# Final Report - Corrections Required Application No. ANEX-24-0003

Report Date: 04/03/2024 Description : Matrix Design Group

Description : Matrix Design Group on behalf of Colorado Springs Equities LLC is submitting a serial annexation petition for seven parcels and Land Use Plan/Rezoning exhibit for a portion of the subdivision known as Rock Creek Mesa. Address : 0 Pawnee RD Colorado Springs CO 80926

Document Filename : 224.023-SURV-RCM ANNEX PLAT 3.pdf

# ANNEXATION PLAT 305, which directly ndary can o ROCK CREEK MESA ADDITION NO. 3 each ex

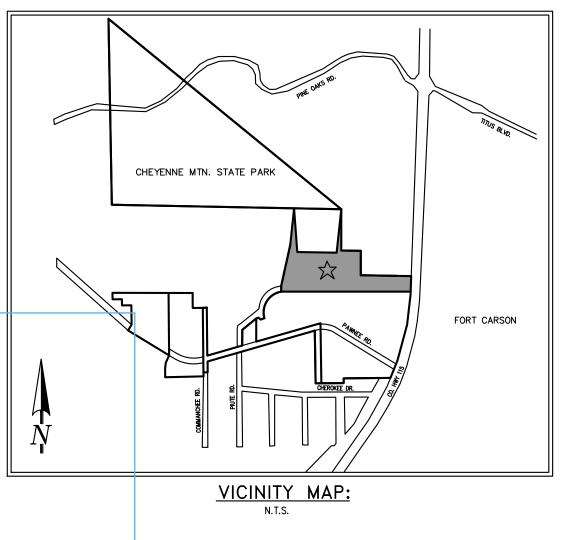
6. AREA OF SITE: 8.35261 ACRE
Please add the area at the end of the legal description	FEMA FLOODPLAIN STATEM THE PROPERTY IS LOCATED WITH POSSIBLE). OBTAINED FROM THE DECEMBER 7, 2018
	BASIS OF BEARINGS:
	ALL BEARINGS HEREIN BASED OF TOWNSHIP 15 SOUTH, RANGE 66 FLUSH WITH GROUND, AT THE WI ALUMINUM CAP STAMPED PLS 19 IS ASSUMED TO BEAR NORTH 88°

The FEMA floodplain zone is incorrect. <u>ENT:</u> Please update to the correct zone.

31717 United Avenue Pueblo, CO 81001 (719) 766-4256 Margie@SECWCD.com (719) 948-2400	Please add quotations around the plat name "Rocl Creek Mesa Addition No. 3						
OWNER:	CITY APPROVAL:						
THE AFOREMENTIONED, COLORADO SPRINGS EQUITIES LLC, A COLORADO LIMITED LIABILITY COMPANY, HAS EXECUTED THIS INSTRUMENT THIS DAY OF, 2024 A.D.	ON BEHALF OF THE CITY OF COL ACCOMPANYING ANNEXATION P				PROVE FOR I	FILING THE	Ē
NAME, TITLE							
STATE OF COLORADO) )SS COUNTY OF EL PASO)	CITY PLANNING DIRECTOR			DATE			
·	CITY ENGINEER						
THE FOREGOING INSTRUMENT WAS ACKNOWLEDGED BEFORE ME THIS DAY OF, 2024 BY NAME, TITLE OF COLORADO SPRINGS EQUITIES LLC, A COLORADO LIMITED LIABILITY COMPANY.	CITT ENGINEER			DATE			
WITNESS MY HAND AND SEAL	THE ANNEXATION OF THE REAL I MADE AND ADOPTED BY THE CIT						
MY COMMISSION EXPIRES:	CITY COUNCIL OF THE CITY OF C A.D.	COLORADO SPRINGS	AT ITS MEETING	G ON DA	Y OF	, 20_
